Agenda
Village of Arlington Heights
Design Commission
Commissions Room 2nd Floor

Arlington Heights Village Hall
33 S. Arlington Heights Road
Arlington Heights, IL 60005
September 8, 2015
6:30 PM

**MINUTES OF
THE VILLAGE OF ARLINGTON HEIGHTS
DESIGN COMMISSION MEETING
HELD AT THE ARLINGTON HEIGHTS MUNICIPAL BUILDING
33 S. ARLINGTON HEIGHTS RD.
AUGUST 25, 2015**

2 PROPOSED NORTH ELEVATION

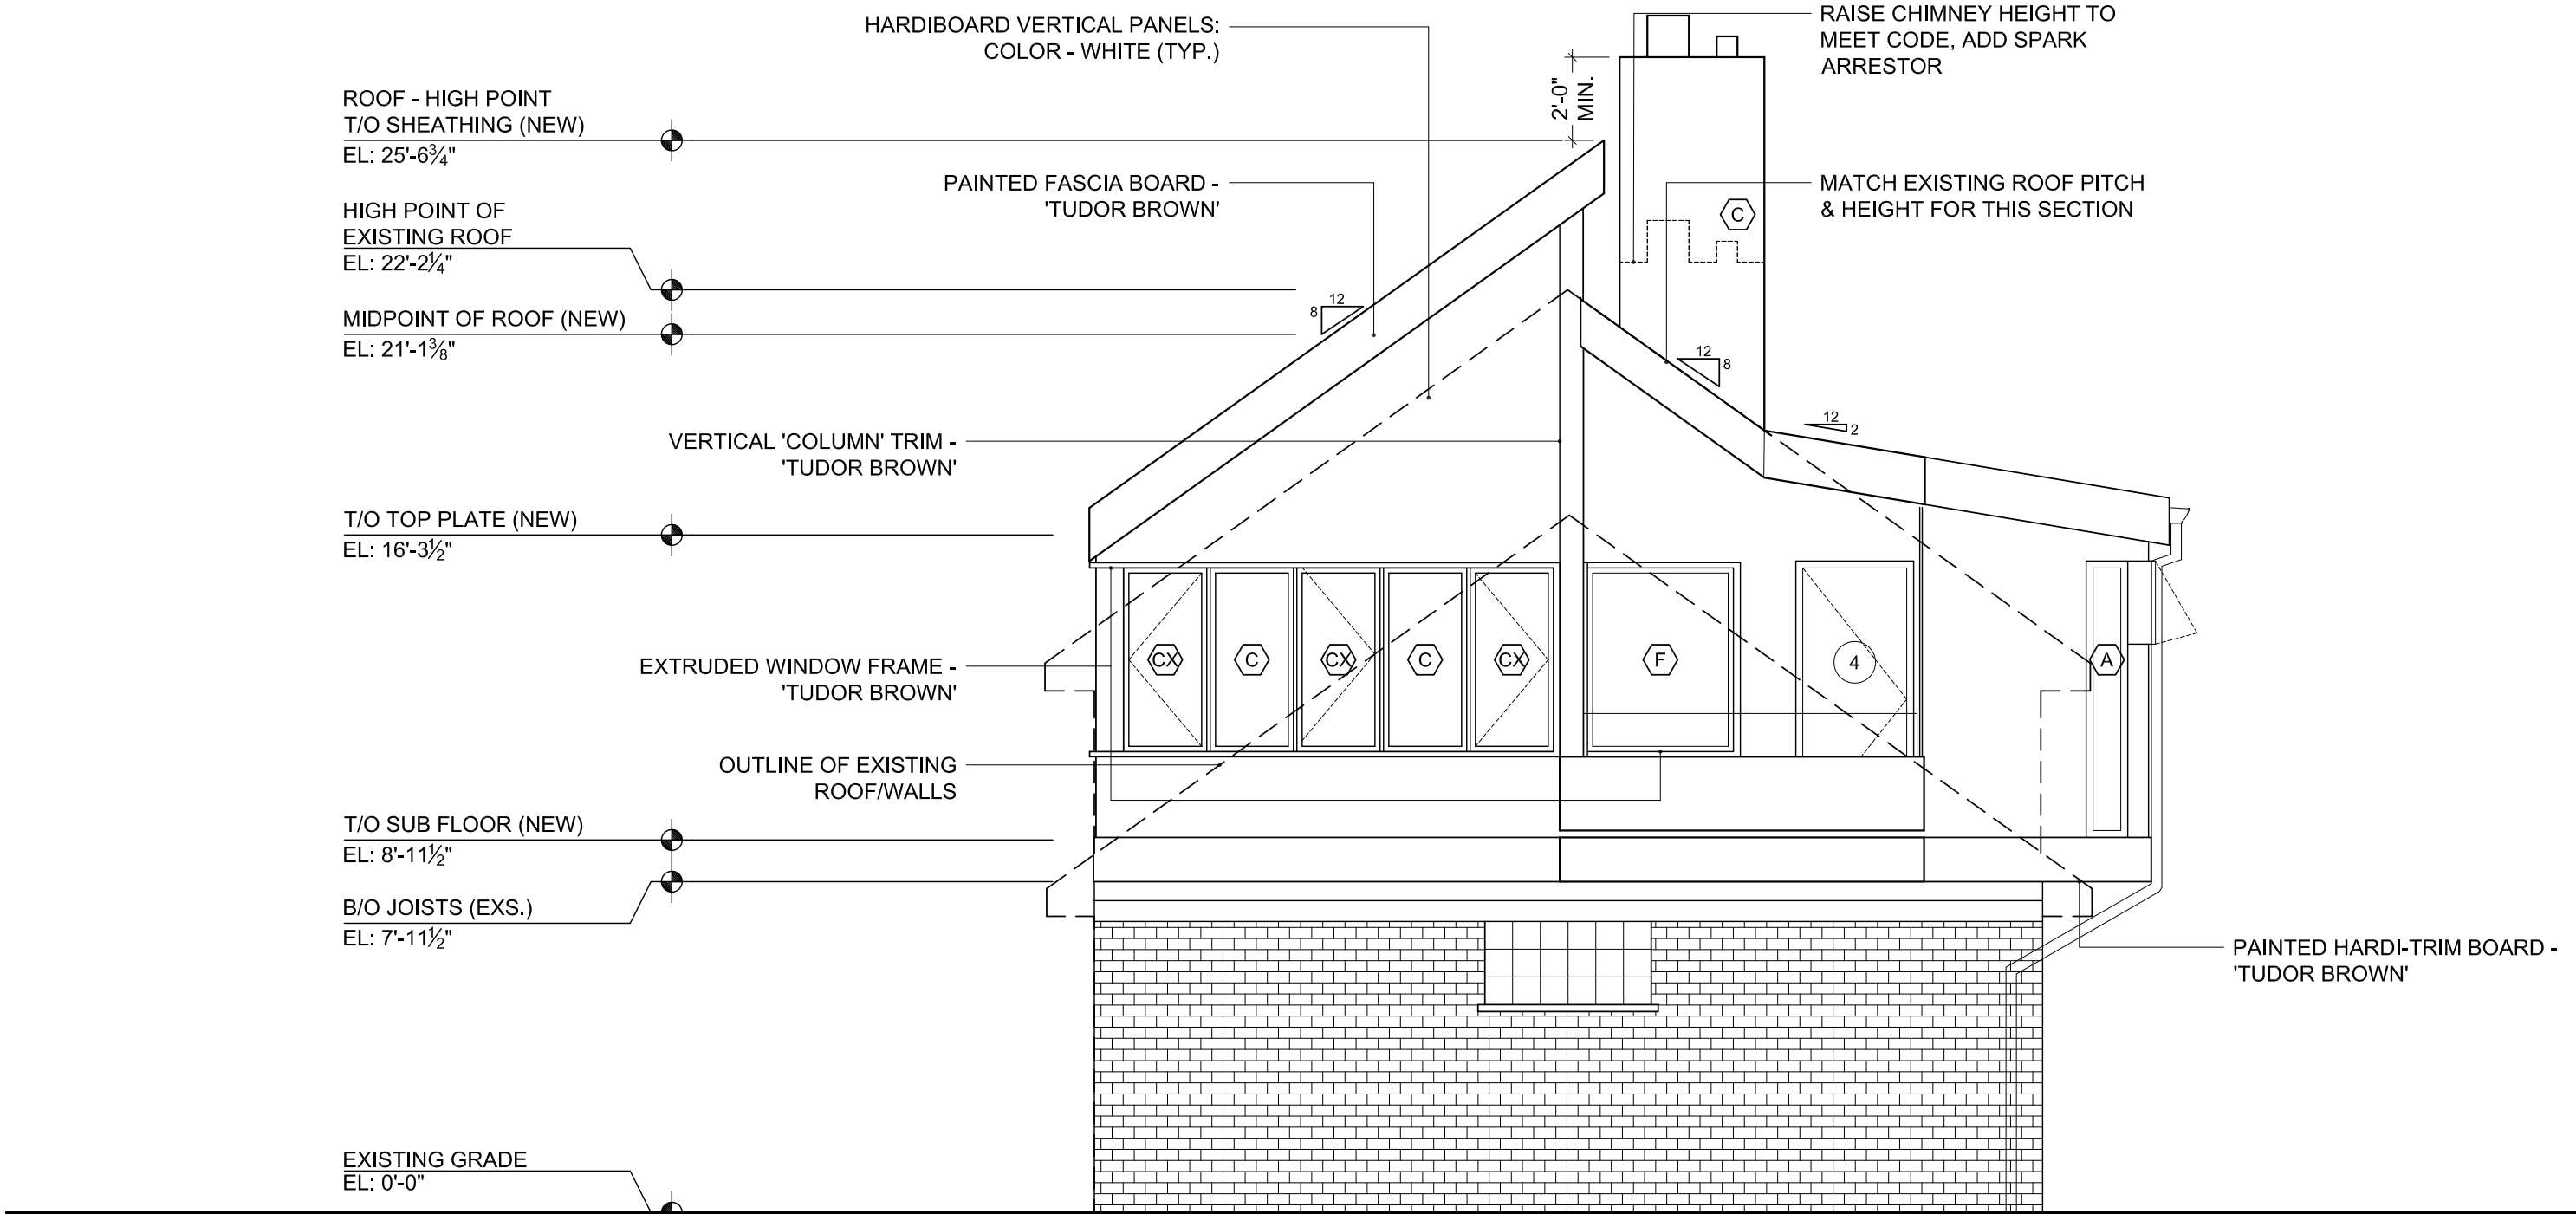
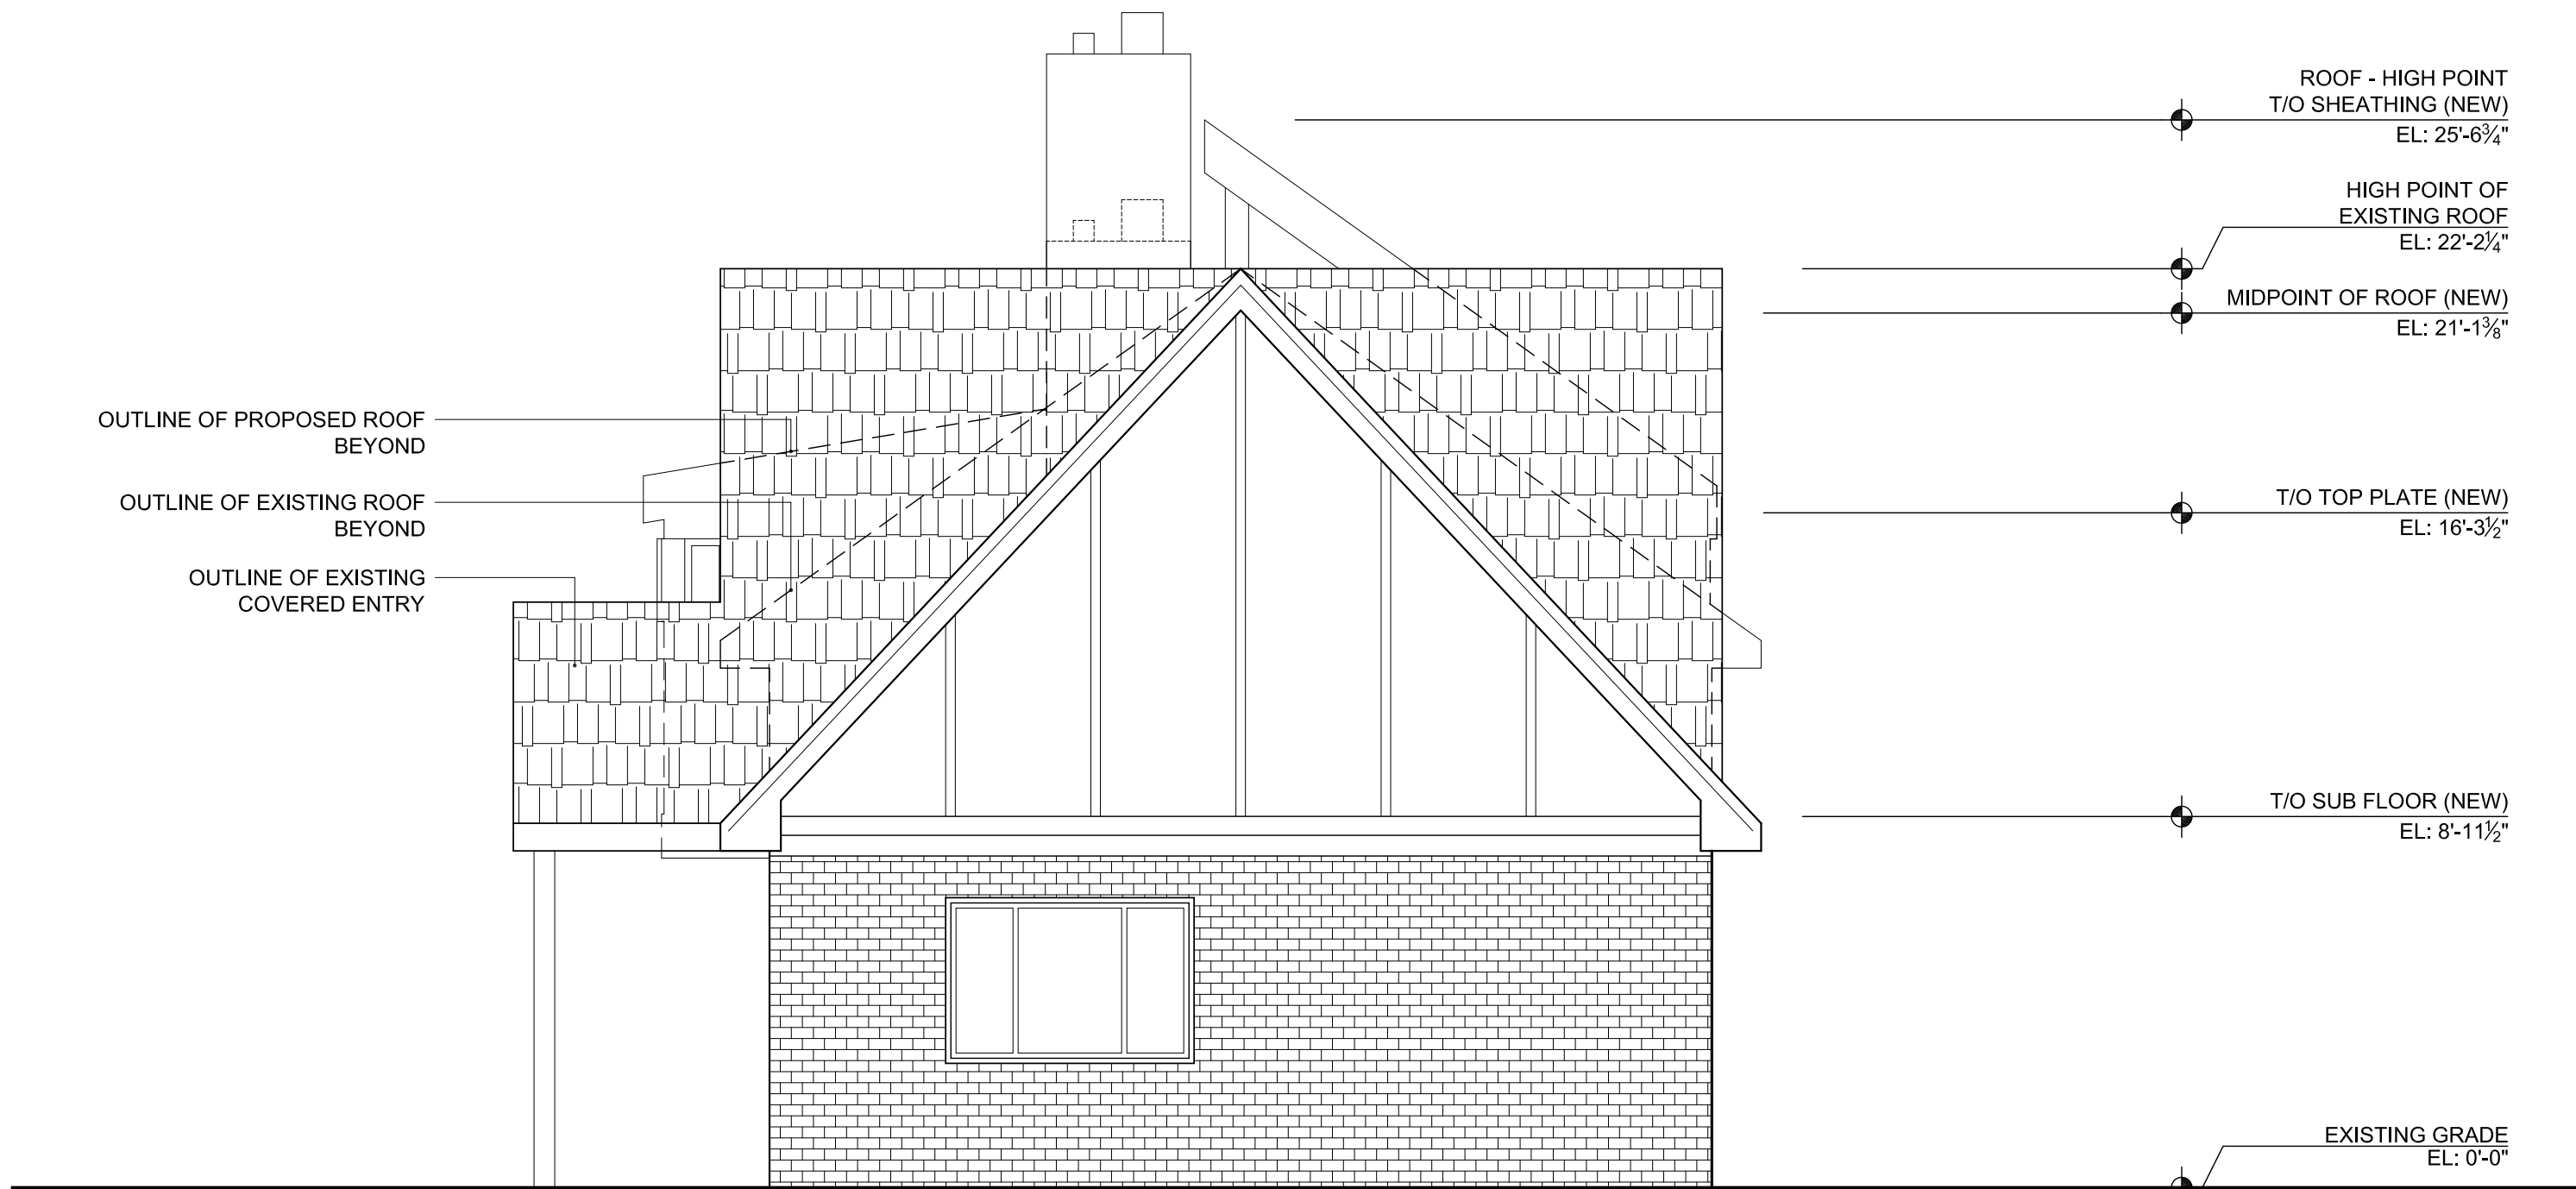
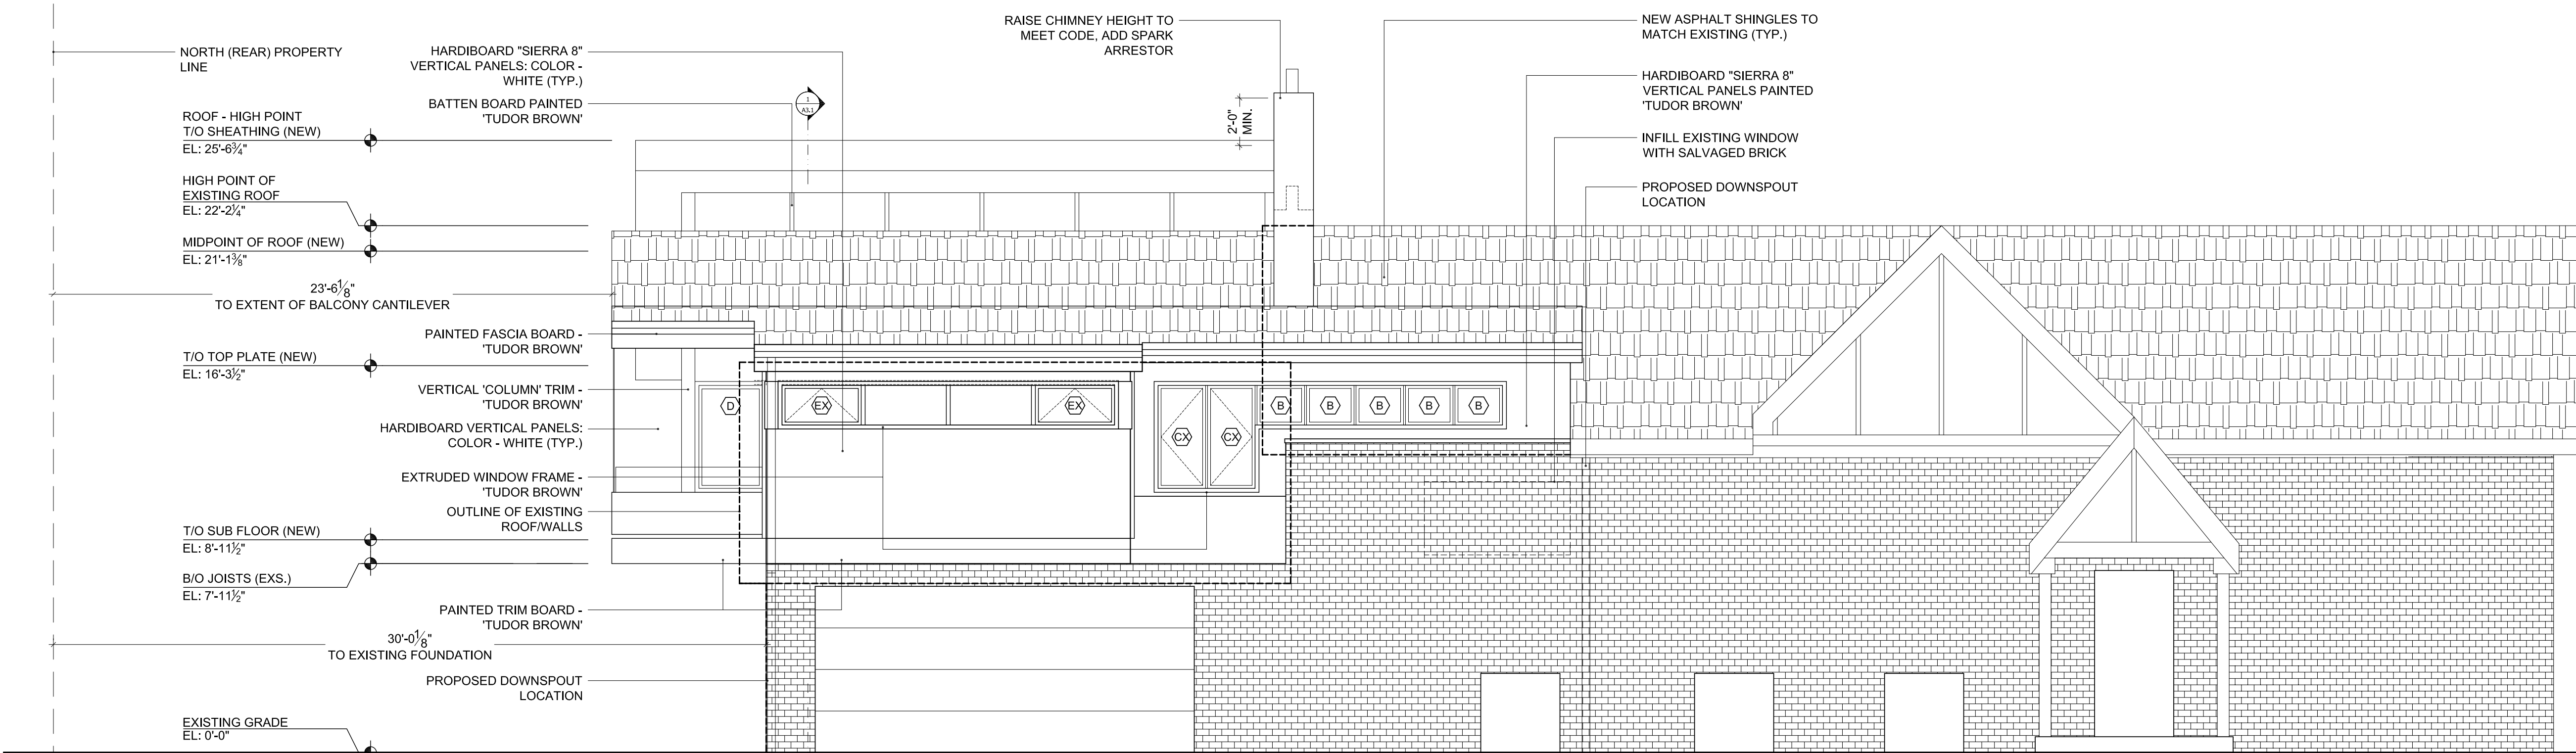
It is recommended that the Design Commission **deny the proposed design and require revisions** to the proposed addition to the existing single-family residence located at 1216 E. Mayfair Road. This recommendation is based upon the architectural plans dated and received on 8-28-15, and the following conditions:

1. Rework the roof lines to blend with the existing home.
2. Revise the design to have more traditional tudor detailing.
3. This review deals with architectural design only and should not be construed to be an approval of, or to have any other impact on, any other zoning and/or land use issues or decisions that stem from zoning, building, signage or any other reviews. In addition to the normal technical review, permit drawings will be reviewed for consistency with the Design Commission and any other Commission or Board approval conditions. It is the architect/homeowner/builder's responsibility to comply with the Design Commission approval and ensure that building permit plans comply with all zoning code, building permit and signage requirements.
4. Compliance with all applicable Federal, State, and Village codes, regulations and policies.
